City of Mississauga Department Comments

Date Finalized: 2024-03-13 File(s): A122.24

The applicant requests the Committee to approve a minor variance to allow a connecting walkway width of 2.30m (approx. 24.76ft) whereas By-law 0225-2007, as amended, permits a maximum connecting walkway width of 1.22m (approx. 13.13ft) in this instance.

Property Address: 972 Springhill Drive

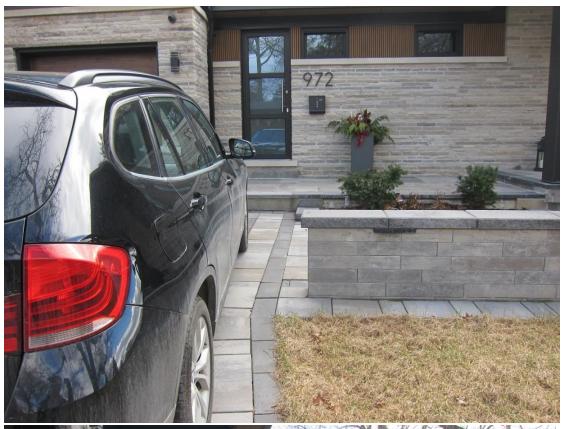
Enclosed are pictures of the existing conditions. We have no drainage related concerns.
